**Ironbark No. 1 Coal Mine – EA Amendment
Application**

Response to DES Additional Information Request

**for Fitzroy Australia Resources Pty
Ltd**

9 June 2023

FIGURE 1

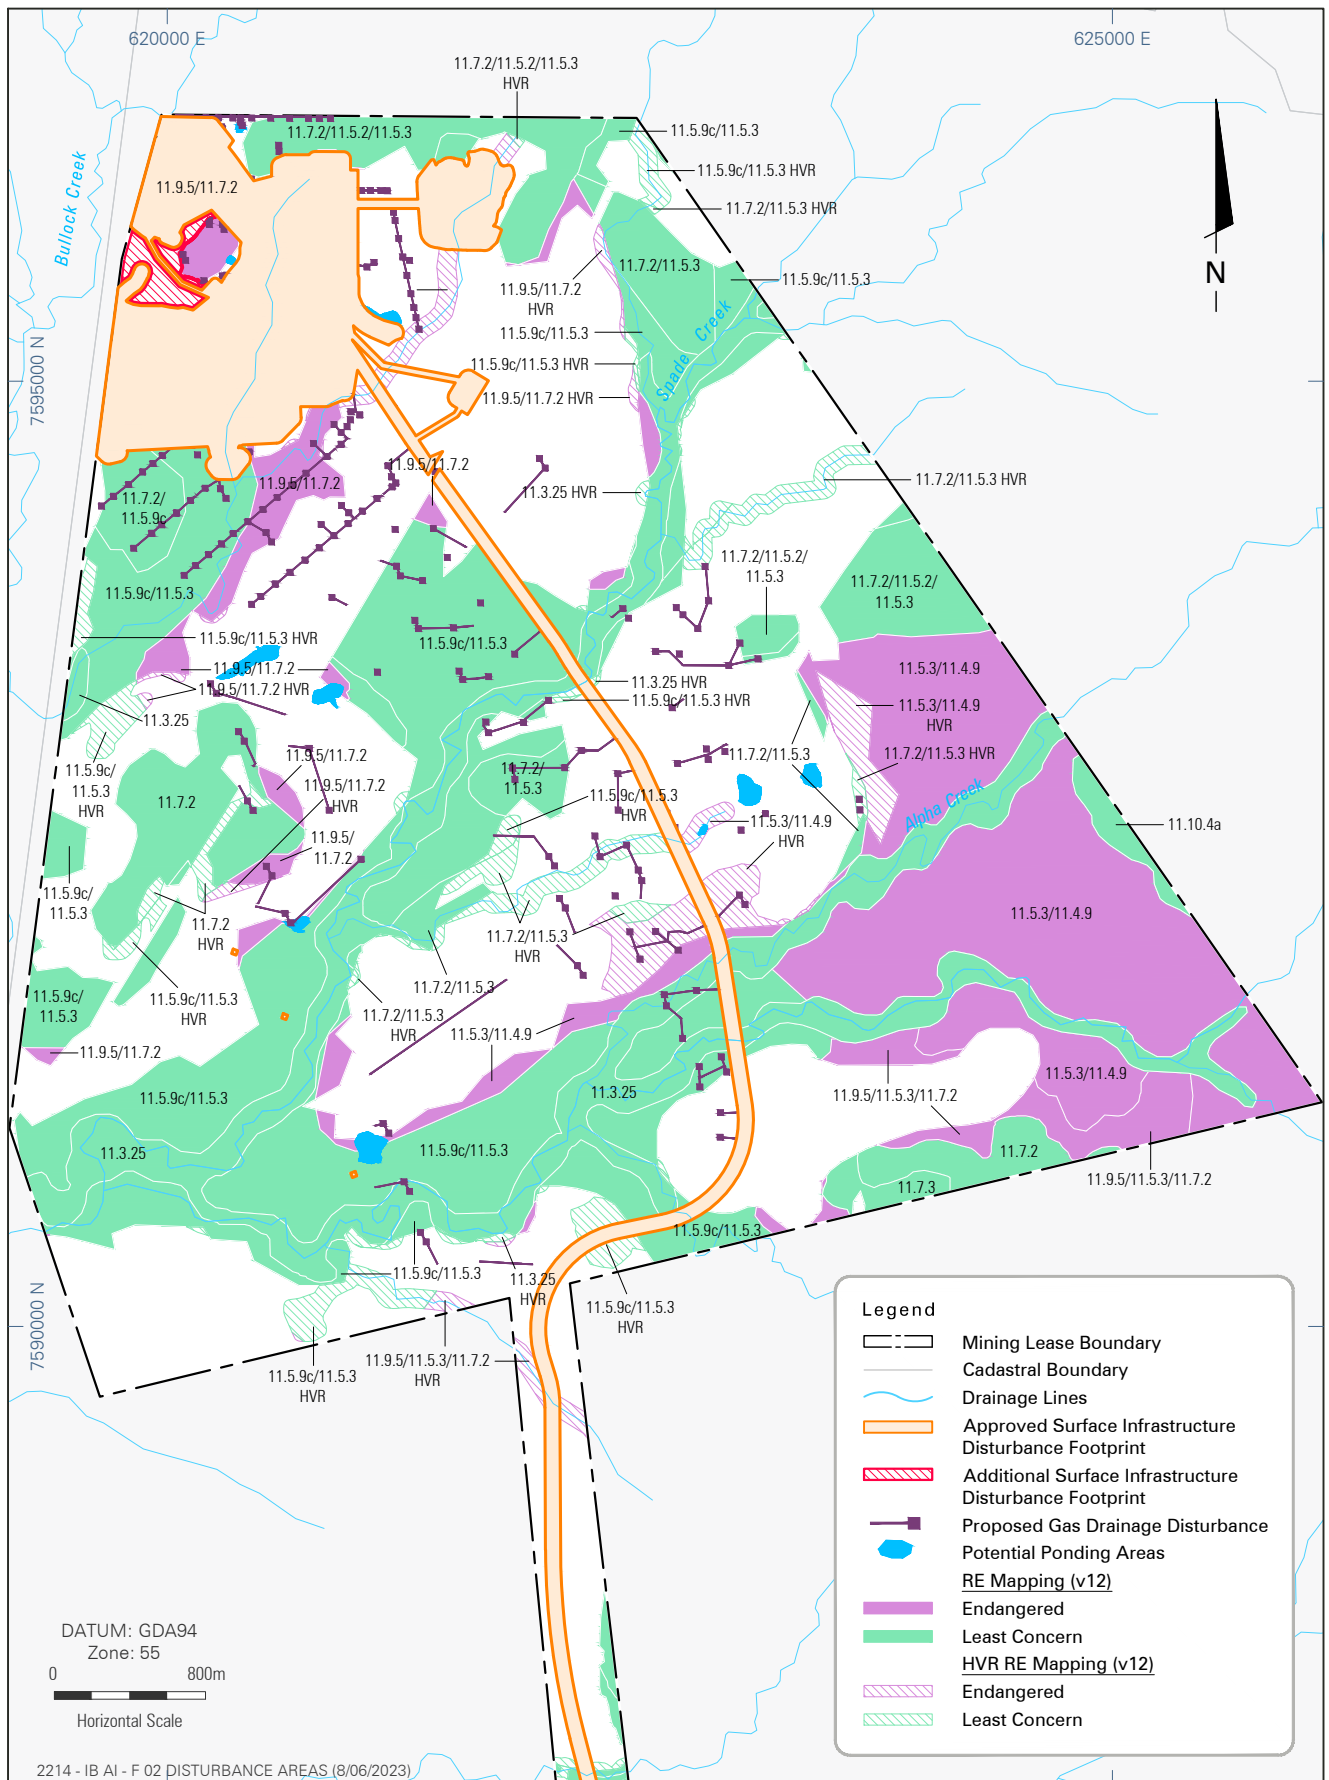
DES Issue: *There is currently no Subsidence Management Plan, Rehabilitation Management Plan or approved PRCP schedule to explain in detail the potential impacts from subsidence (and subsidence repair) of the underground mining operation on environmental values and how these impacts will be avoided, mitigated, managed or offset.*

DES Request: *In the absence of these documents, describe in sufficient detail and quantify areas and locations (in figures) where possible, all potential above ground disturbance from the revised underground mine layout including gas drainage activities, subsidence (predicted ponding, cracking etc.), interference with watercourses/drainage lines, vegetation clearing and subsidence rehabilitation/repairs.*

Figure 1 shows the perimeter of each longwall panel in the revised mine layout where the zone of residual tensile strain and potential surface cracking will occur.

The LOM vegetation disturbance area has been recalculated for the revised longwall layout using the same methodology and indicates that a total of 1.8 ha of remnant vegetation disturbance could occur for the revised longwall layout, beyond the approved disturbance areas (Figure 1).

FIGURE 3

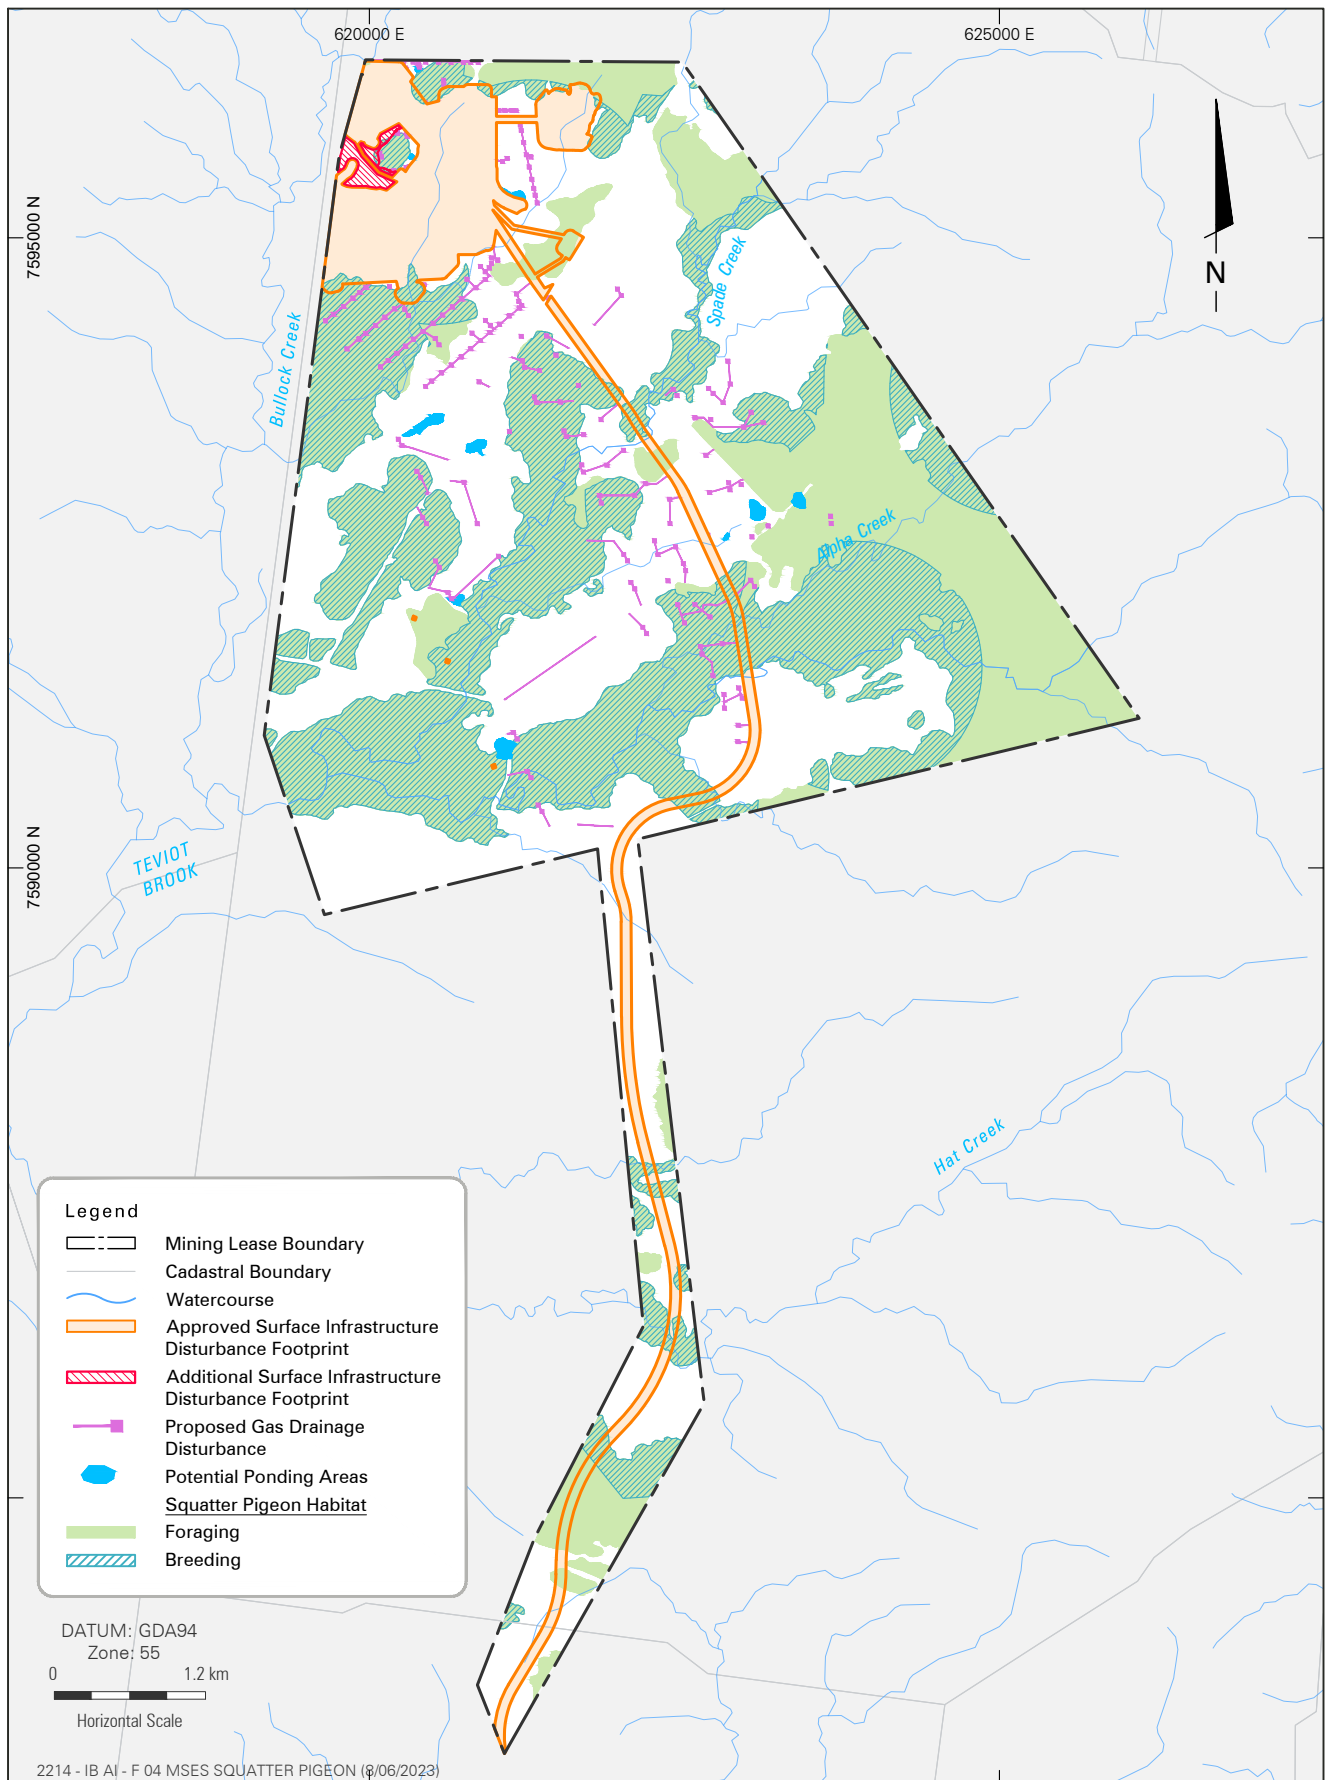
DES Issue: Condition I1 of the EA currently permits the subsidence of Spade Creek, subject to conditions I1 to I13. The proposed underground mine layout involving longwall mining also occurs under Bullock Creek East and South Spade Creek / Alpha Creek. The EPBC approval requires that all management measures, monitoring, reporting and corrective actions regarding the subsidence of Spade Creek are also applied to Alpha Creek.

DES Request: Provide further information about the subsidence risk to Bullock Creek East and South Spade Creek / Alpha Creek.

Figure 3 shows the creeks and tributaries traversing the mine site in relation to the approved and revised longwall layouts. This figure shows that the revised longwall layout will result in a small reduction in the total subsided reach length for the eastern tributary of Bullock Creek and the southern tributaries of Alpha Creek. It also shows that the subsided reach of the southern tributary of Spade Creek is unchanged.

Sections of the subsided creeks and drainage lines where elevated bed levels will occur due to subsidence have been identified based on a detailed review of the subsided surface contours. The areas are shown in Figure 3. The depression in the creek beds immediately upstream of these areas will naturally fill with sediment and the elevated bed areas will naturally erode during subsequent flow events to achieve a new bed level equilibrium. These areas will be carefully monitored as part of the monitoring program described above.

As discussed in Section 2.1, the length of the eastern tributaries of Bullock Creek and the southern tributaries of Spade Creek and Alpha Creek that will be subsided by the revised longwall layout are the same or less than the approved layout (Figure 3). Locations in the creeks where subsidence will result in elevated bed levels are

also identified in Figure 3. These areas will be subject to erosion in order to reach a new equilibrium. The proposed management of subsidence of drainage lines, specially addresses monitoring and management of areas of potential creek instability.
